**Benjamin Wallace - Re: FW: 2211 Congress St - Unum HO1 - permit 2013-00458**

**From:** Benjamin Wallace [<mailto:wallaceb@portlandmaine.gov>]  
**Sent:** Thursday, April 25, 2013 11:01 AM  
**To:** Brian Curley  
**Cc:** Jeanie Bourke  
**Subject:** 2211 Congress St - Unum HO1 - permit 2013-00458

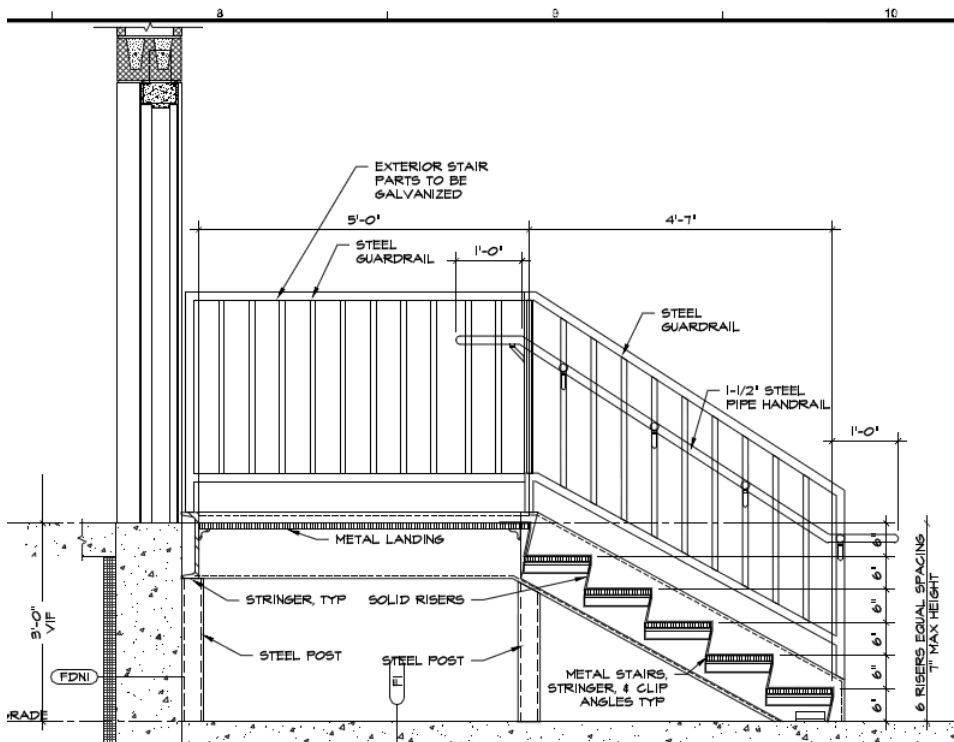
- Sheet A-504, detail 13 shows a handrail arrangement that doesn't comply with NFPA 101:7.2.2.4.4.10.
  - The bottom of the handrail is still not correct. Please make the required correction(s) to sheet A-504.

ITEM 1 -The extensions have been added see diagram below.

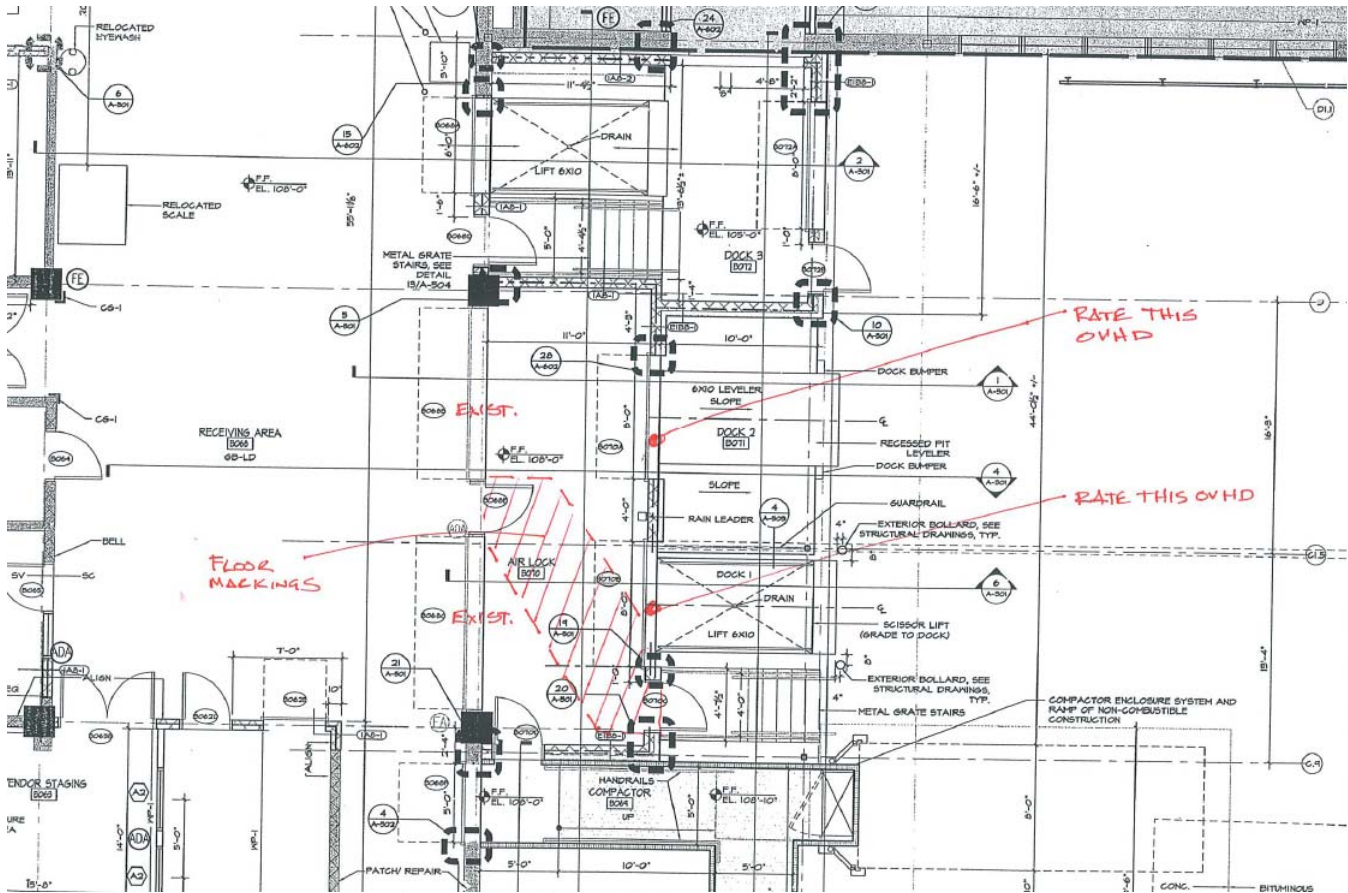
- The door schedule does not indicate a fire resistance rating for B068C. The wall it penetrates is indicated as a 1-hour assembly per sheet A-001. The fire resistance rating of that door assembly must comply with NFPA 101:8.3.4 (minimum 45-minutes and self- or automatic-closing).

ITEM 3 - We would like consideration for rating the exterior OVHD doors (B070A and B070B ) to the Air Lock B070, Posting the described signage and stripping the floor(discussed in item 6). Door B068C is an existing Overhead Door. Below is diagram. **Ok.**
